ADDENDUM NO. 2

**TOWN OF LAKEVIEW  
MCDONALD PARK SPLASH PAD**

Issued this 29th day of November 2022

See attached revised plan sheets C4, S1 and S4.

**C4**

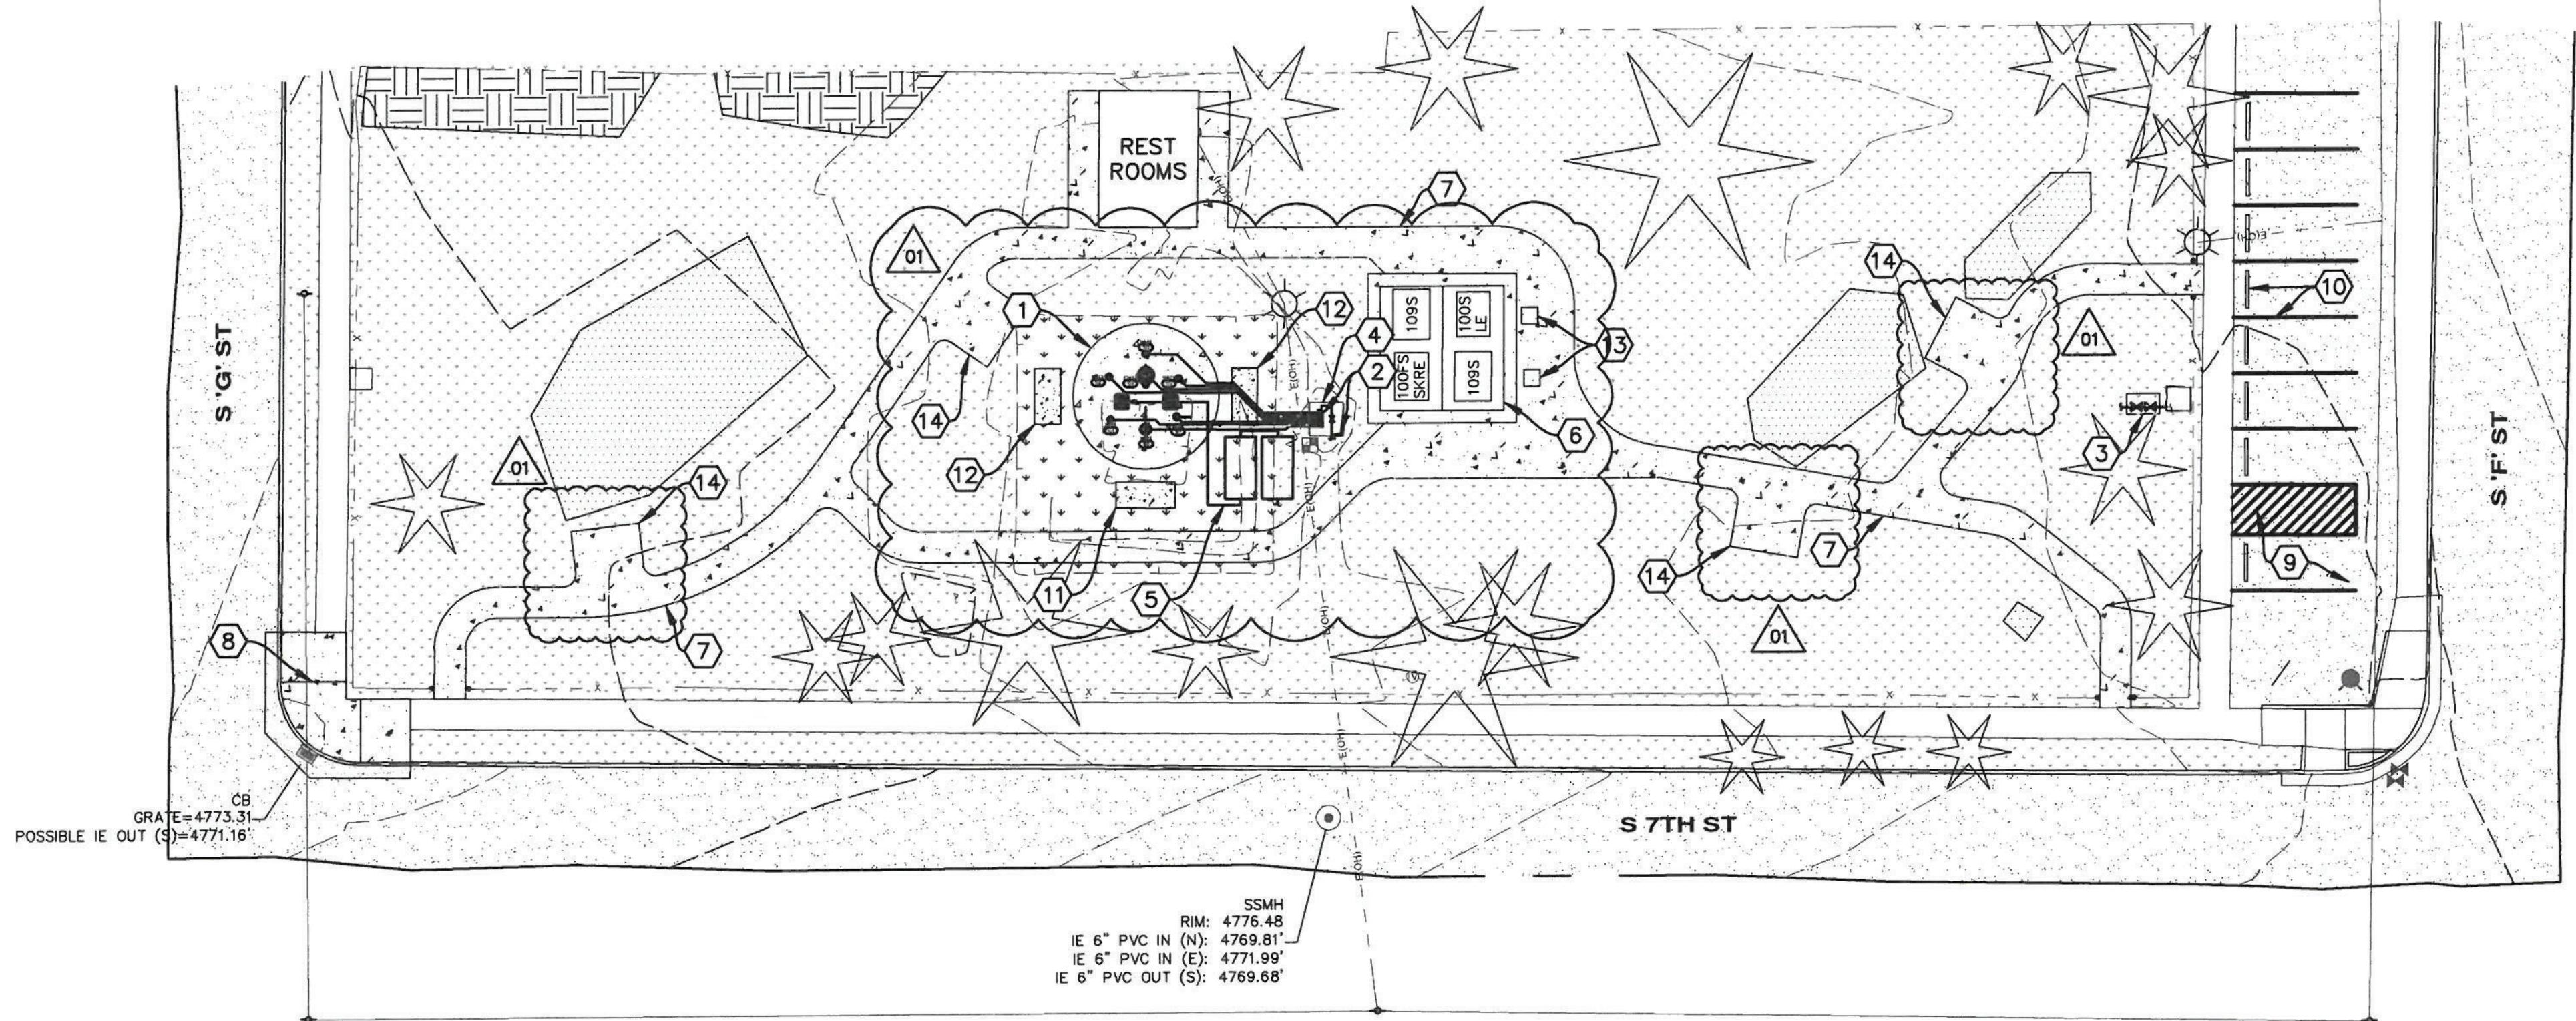
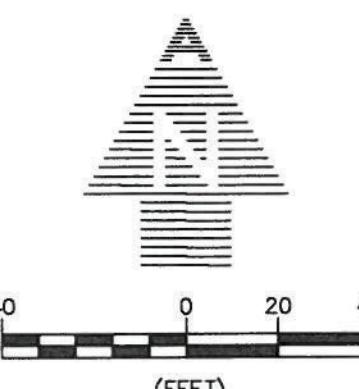
Q6: On the splash pad the slope to the drain is there a maximum slope? 2% ada or more or less

A6: See attached revised plans for clarification.

- ① INSTALL WATER ODYSSEY EQUIPMENT ON 23'-7" DIAMETER CONCRETE PAD, AT GRADE. REFER TO SHEET S1 FOR CONCRETE AND REINFORCEMENT REQUIREMENTS. CONTRACTOR TO SLOPE PAD FROM OUTSIDE EDGE TO WATER ODYSSEY DRAINS AT 1.50%, TYP.. CONTRACTOR TO INSTALL SOD IN AREA BETWEEN DEMOLISHED WADING POOL AND PROPOSED SPLASH PAD. SOD AREA IS APPROXIMATELY 1,250 SQUARE FEET.

S1

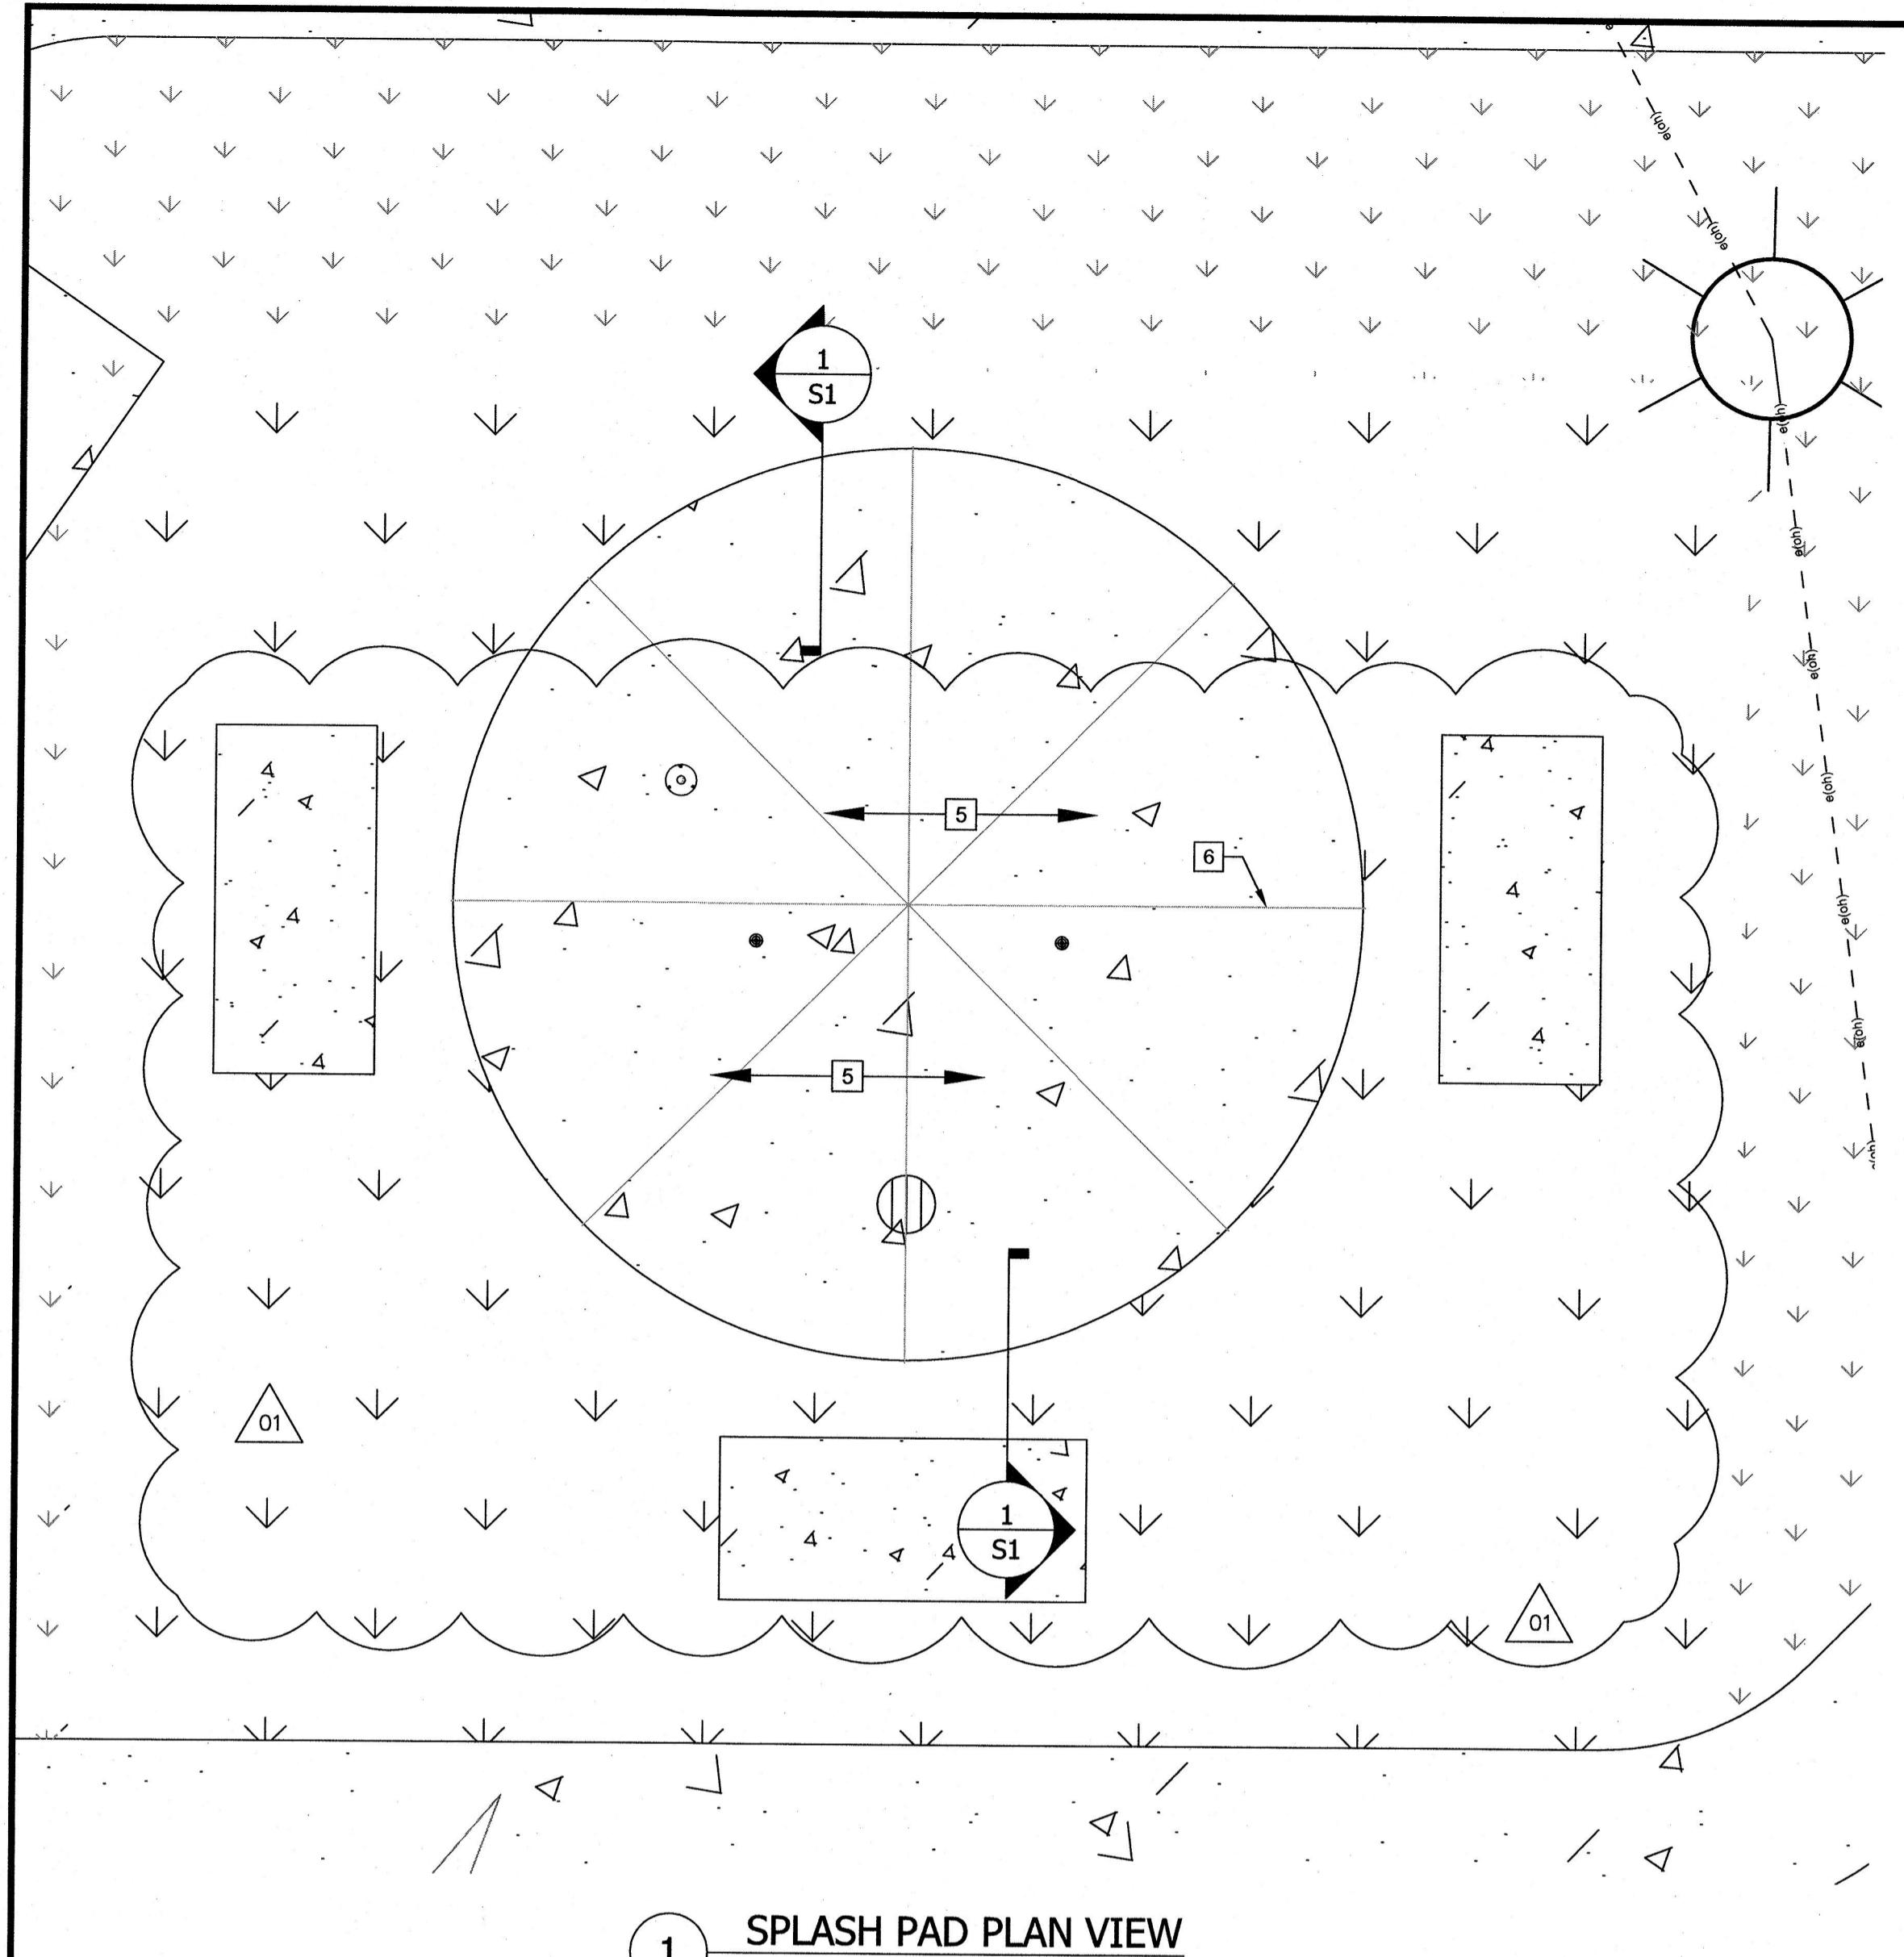
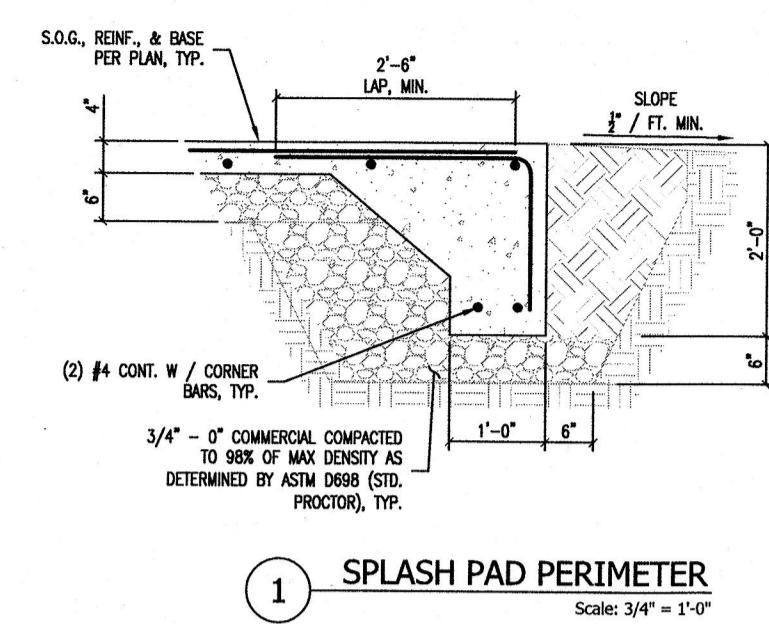
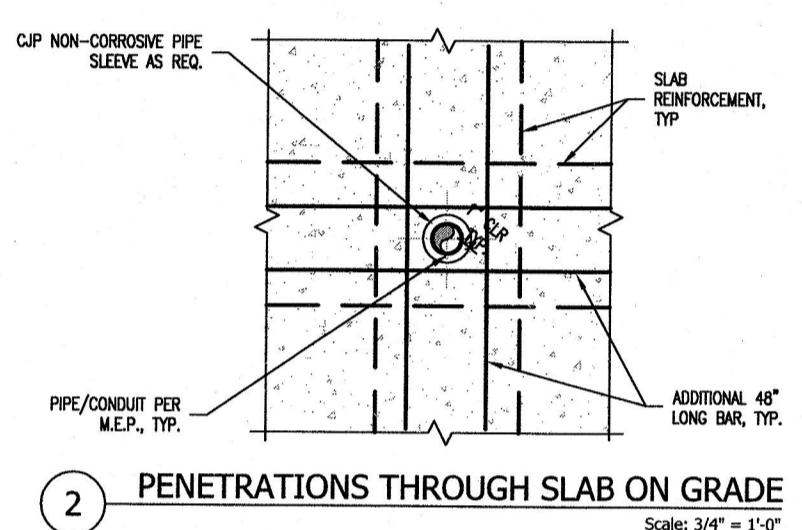
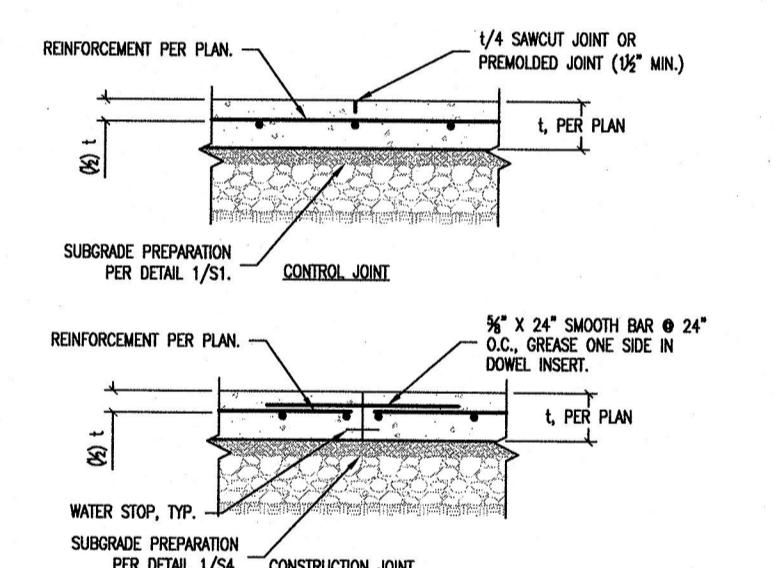
- Per the aquatic playground manufacturer, all structural concrete must be a minimum of 3,000psi.
